**US Army Corps
of Engineers** ®
Wilmington District

FINDING OF NO SIGNIFICANT IMPACT

JORDAN LAKE AERATION SYSTEM
FOR THE CARY/APEX WATER TREATMENT FACILITY
CHATHAM COUNTY, NORTH CAROLINA

September 2013

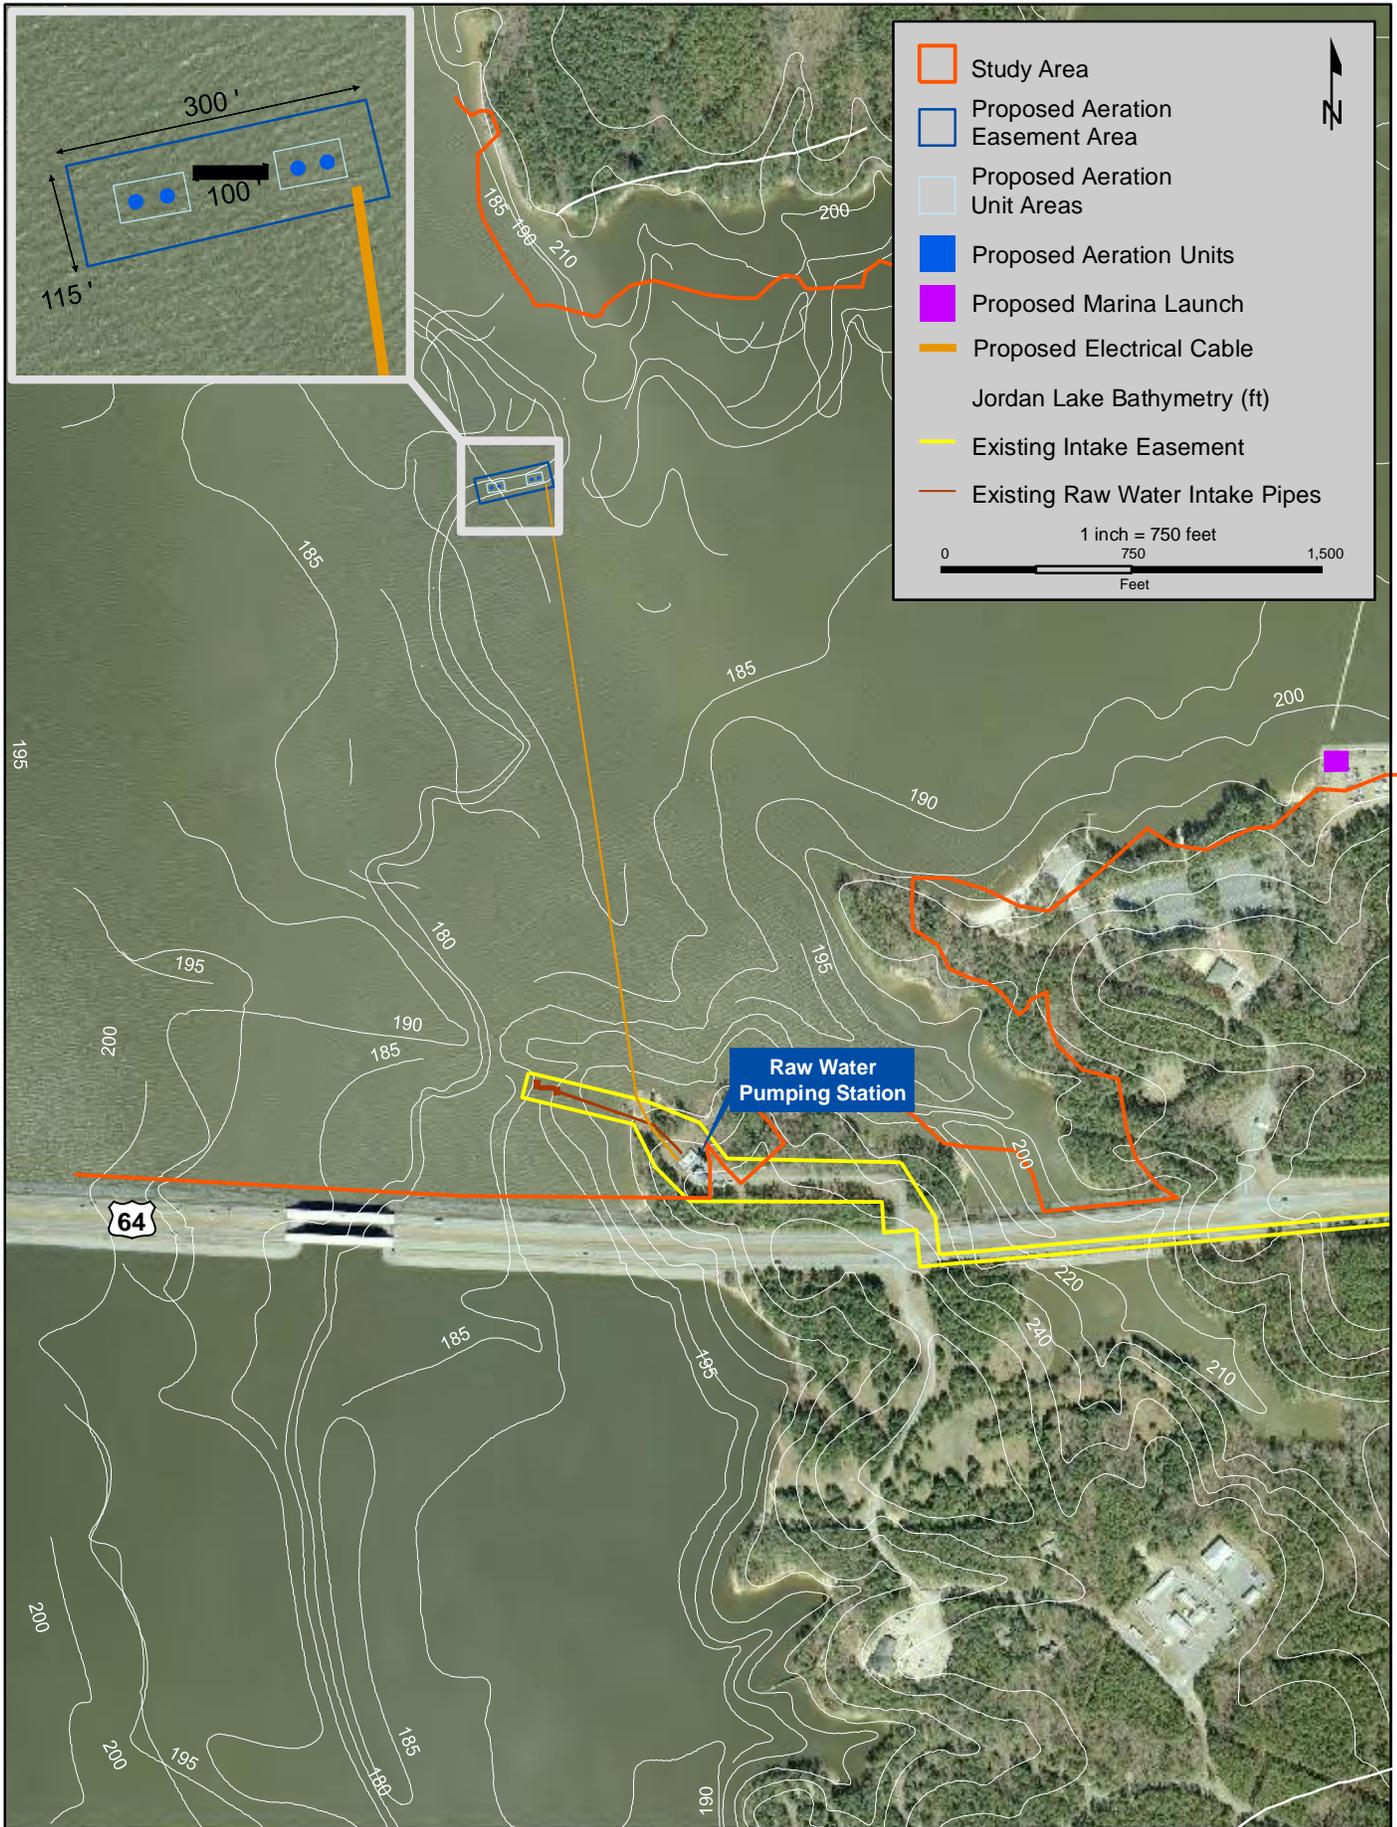
Comment 1: Referring to Exhibit 13, what are the dimensions of the outer limits of the exclusion zone to be marked with "Keep Out" buoys? Table 6 (pg 21) is misleading and does not indicate total area to be restricted from navigation. According to Exhibit 13, the restricted navigation area is larger than indicated in the EA report at Table 6.

Response to Comment 1: Although not included in Exhibit 13, the dimensions of the outer limits of the exclusion zone are shown in Exhibit 2 and further described on page 35, "The proposed aeration system units, totaling 0.8 acre, would be off limits to boaters and other recreational watercraft. This area would be marked appropriately to protect the recreational safety of Jordan Lake users during day and night."
